RE: Supplemental Information Package for The Seville on Boston Harbor, LLC East Boston MA 02128

# **PNF Supplemental Information with response to comments**

PROJECT NAME: **THE SEVILLE ON BOSTON HARBOR, LLC**

① Site Plan  
1" = 20' 0"

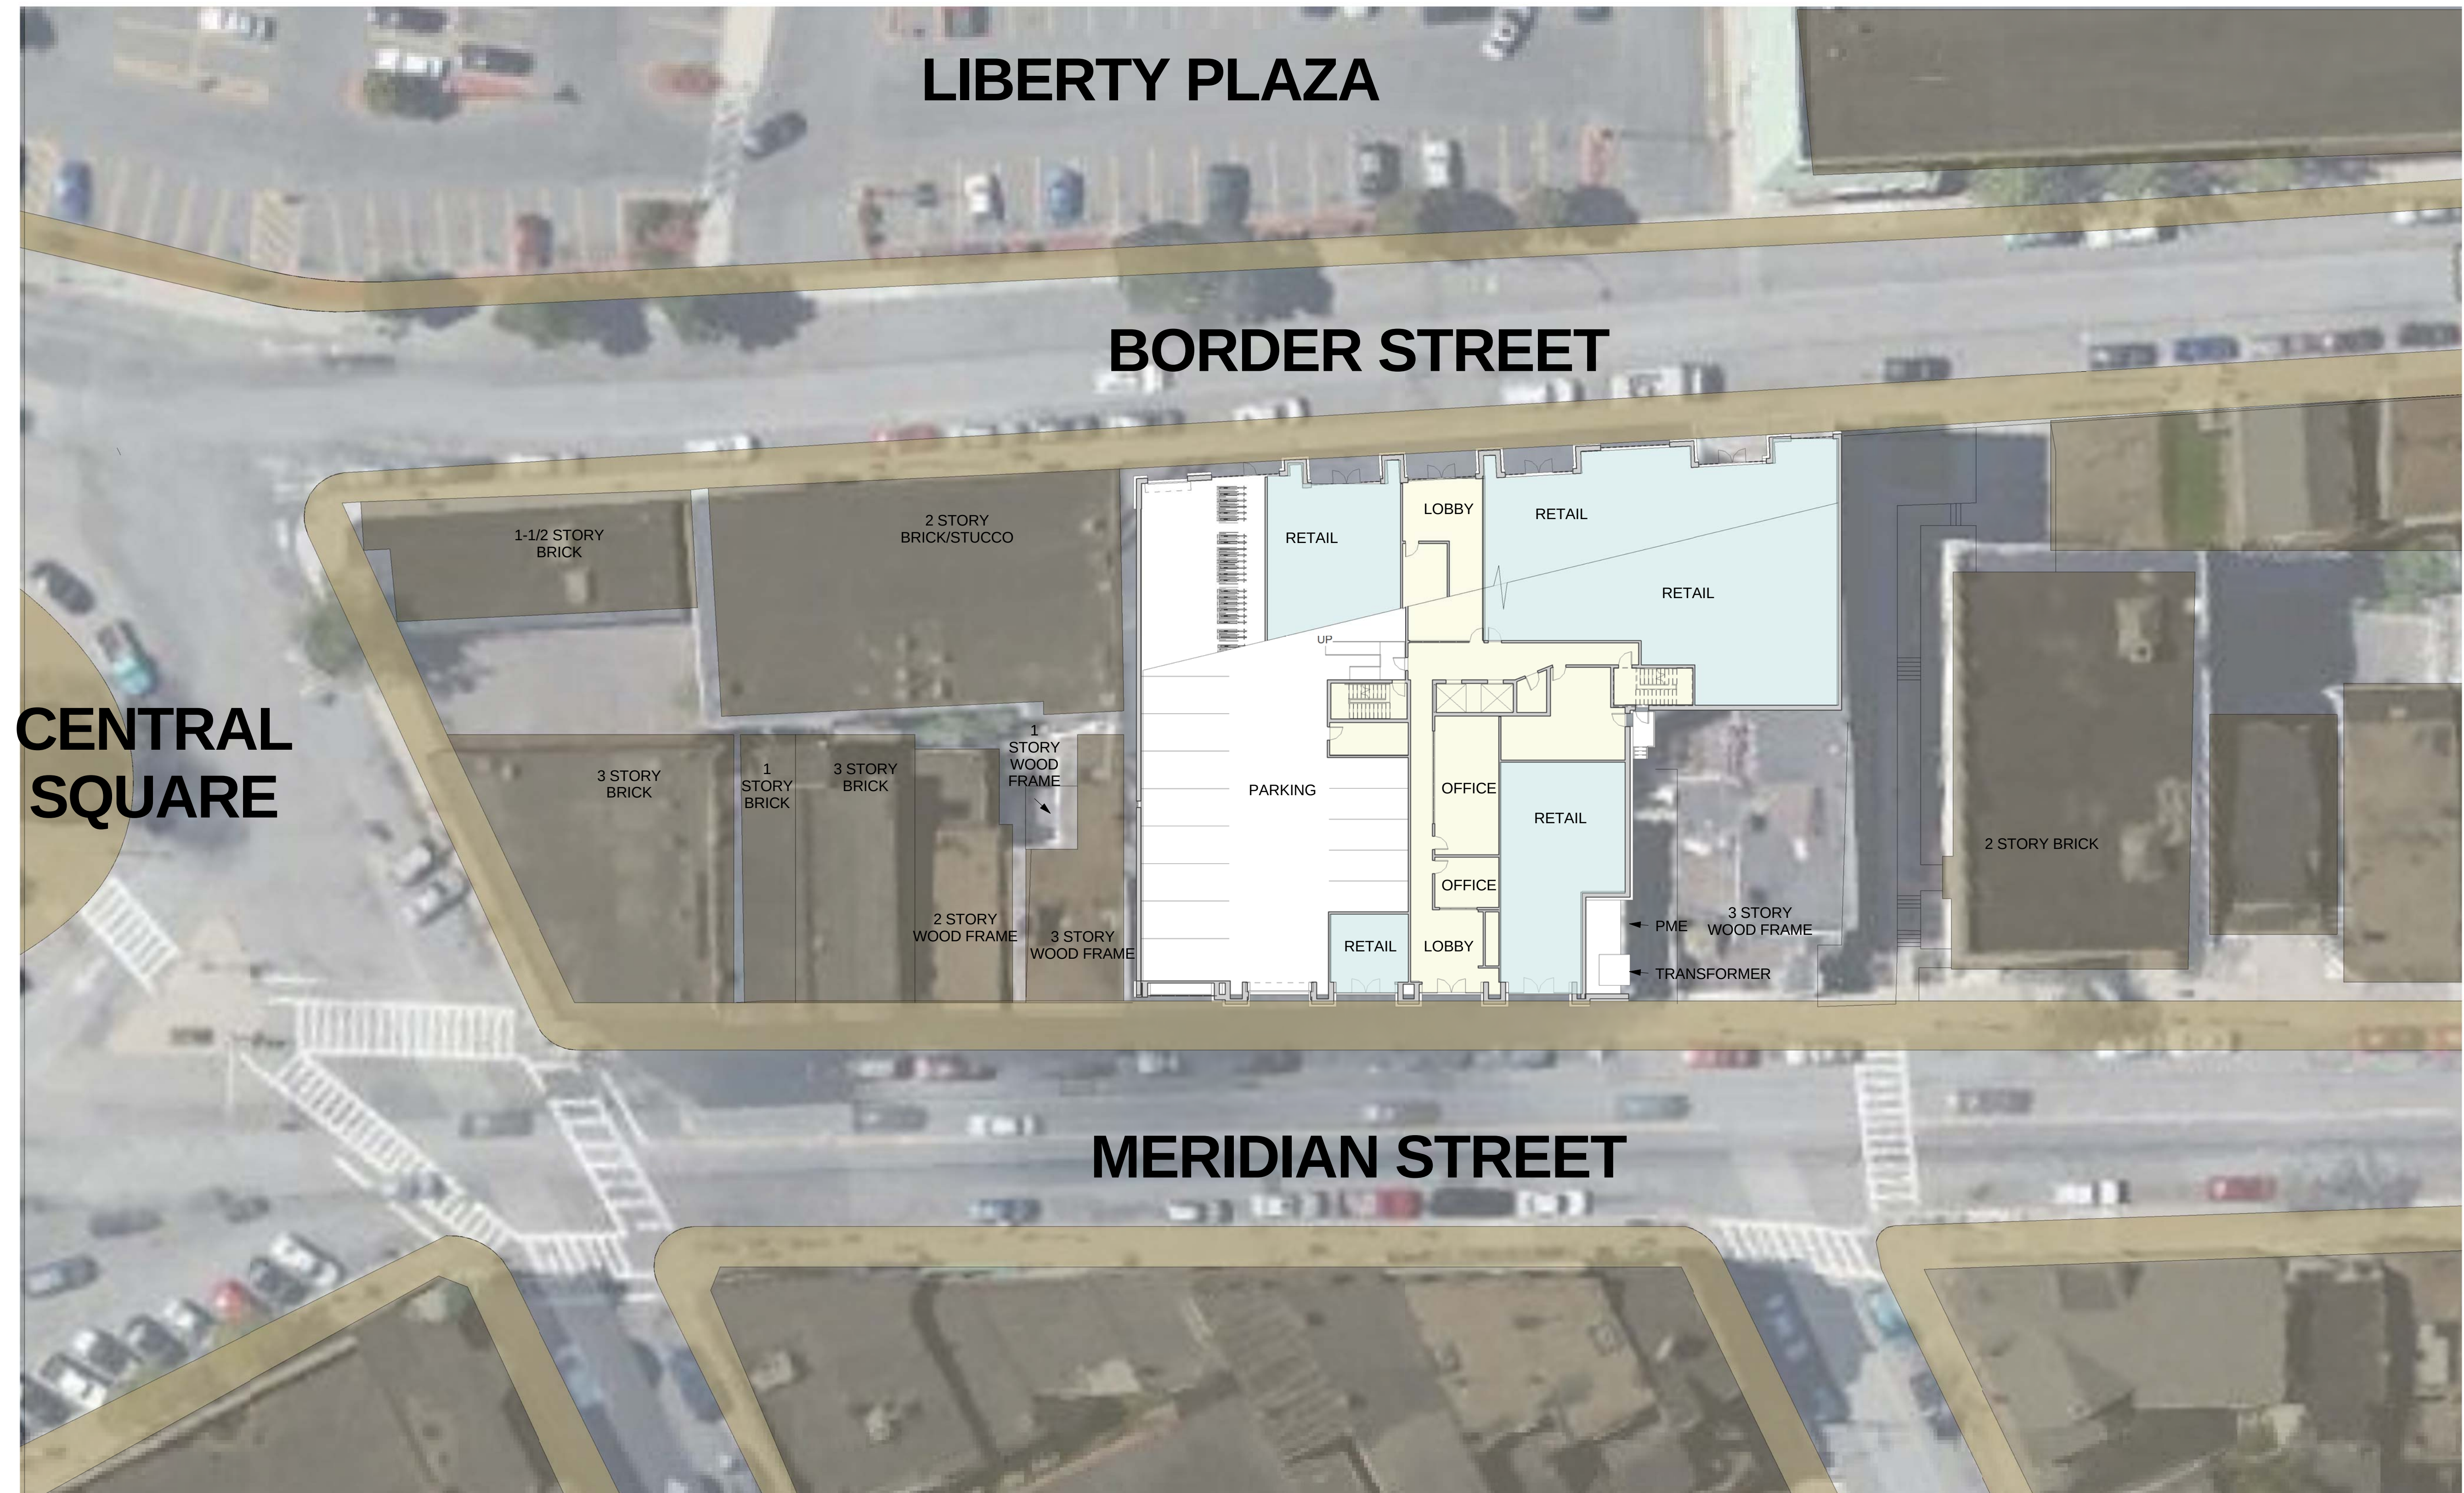
Add updated site plan – see plans

## Meridian Street Level Plan

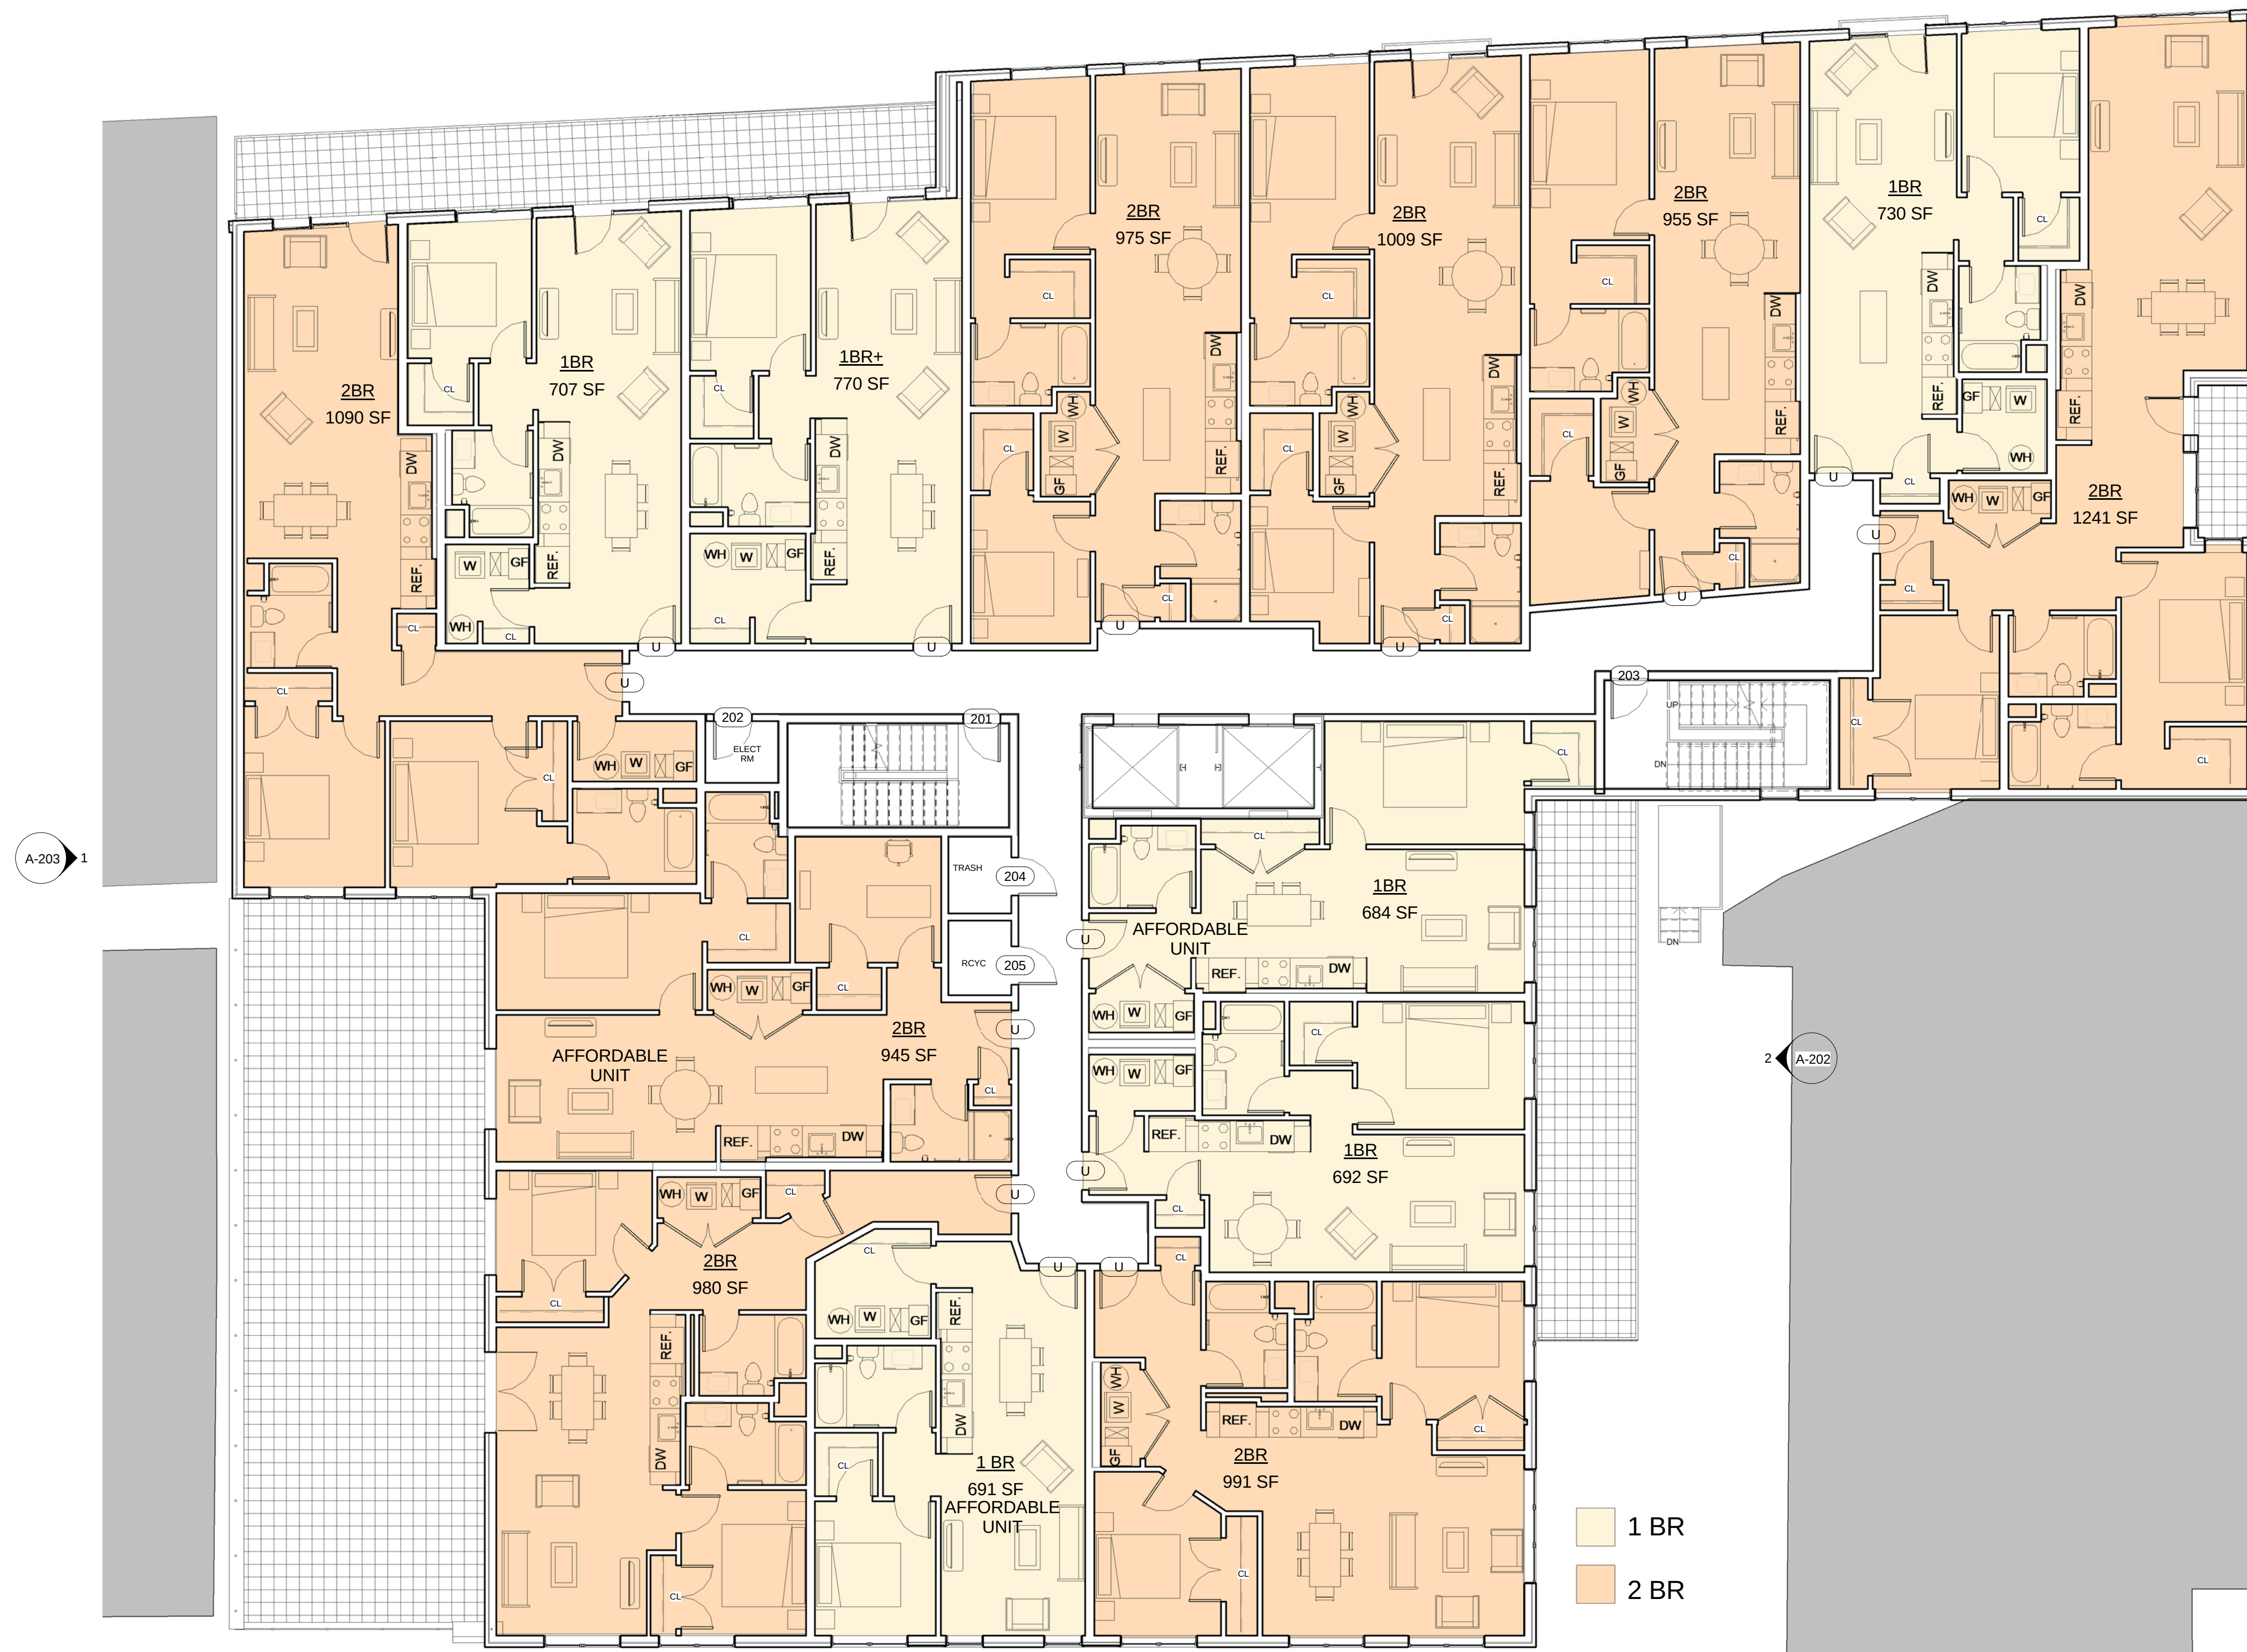
BRA – Meridian Street storefront space near the garage entry should be increased at the street front where the street storefront glass systems are to be able to house a small retail space. Complied – see plans 300+sf added Meridian plate
